UNITED STATES PATENT AND TRADEMARK OFFICE

APPLICATION NO.	FILING DATE	FIRST NAMED INVENTOR	ATTORNEY DOCKET NO.	CONFIRMATION NO.
10/609,438	07/01/2003	Je-Chang Jeong	Q75265	7906

Office Action Summary	Application No.	Applicant(s)	
	10/609,438	JEONG ET AL.	
	Examiner	Art Unit	
	Vu Le	2613

DETAILED ACTION

FIGURE 4

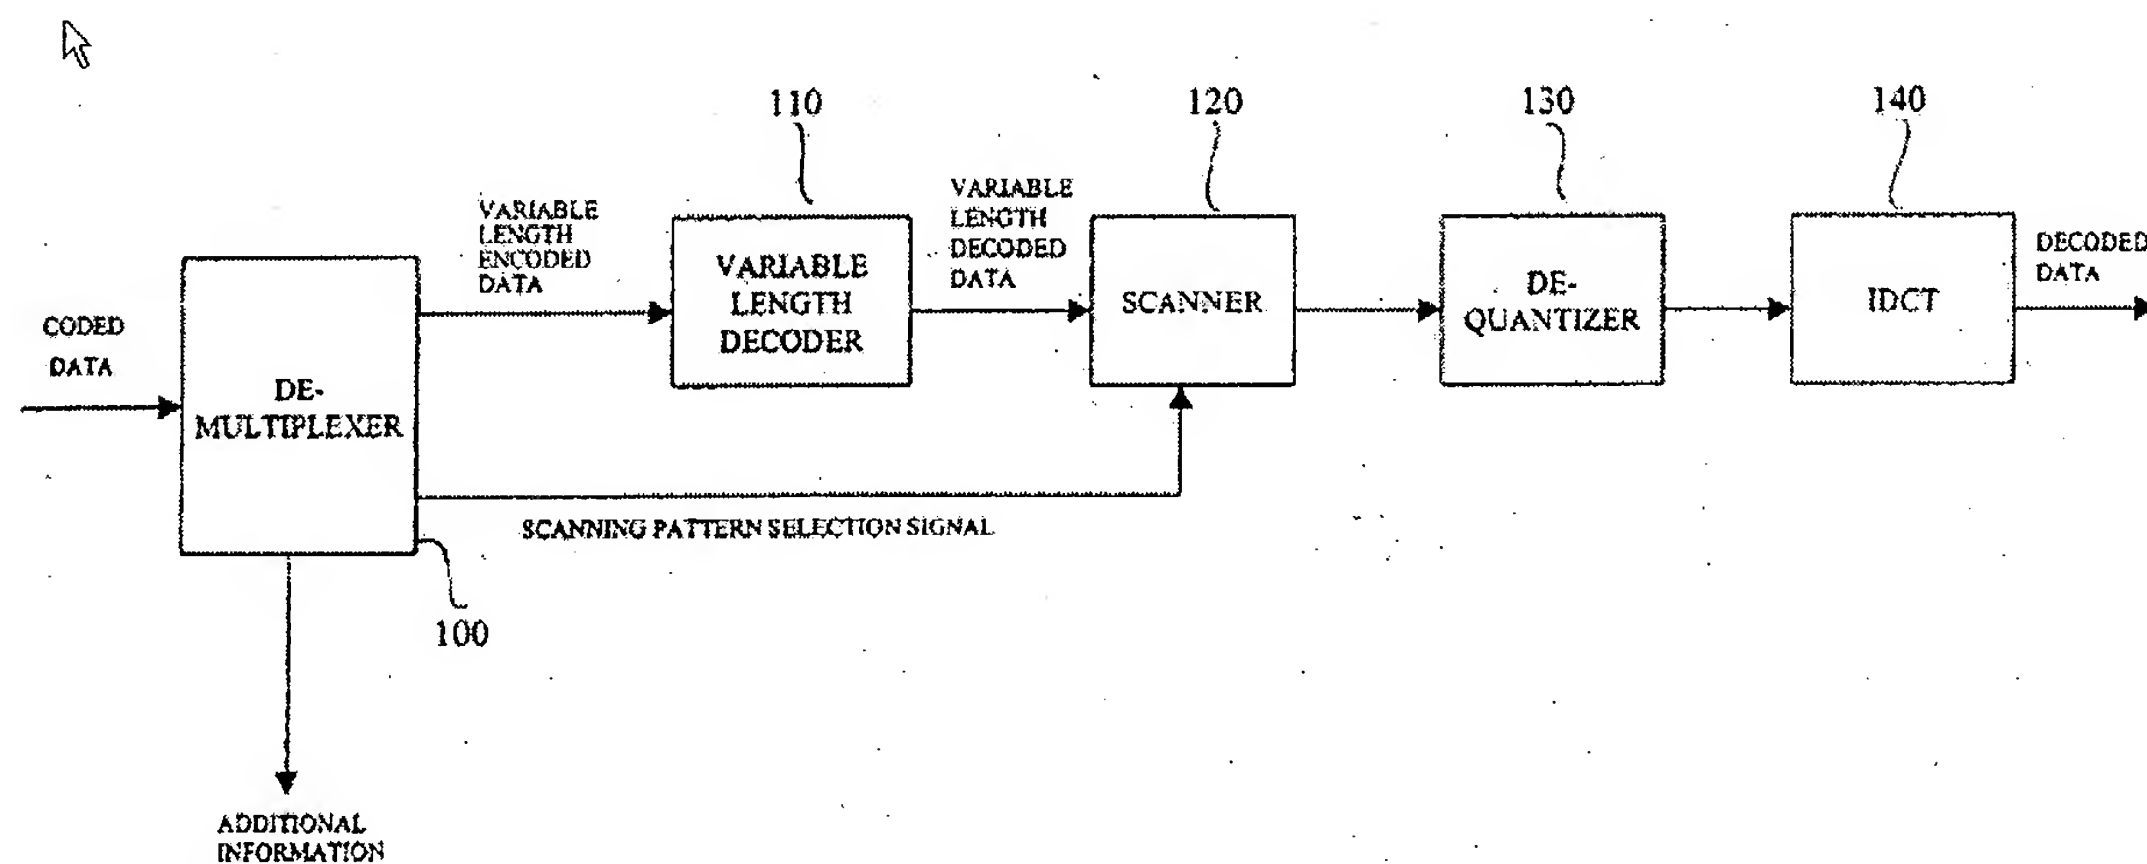
3. The amendment filed July 1, 2003 is objected to under 35 U.S.C. 132 because it introduces new matter into the disclosure. 35 U.S.C. 132 states that no amendment shall introduce new matter into the disclosure of the invention. The added material which is not supported by the original disclosure is as follows:

In the drawings:

The addition of new figure 4 is shown below:

Applicant is required to cancel the new matter in the reply to this Office Action.
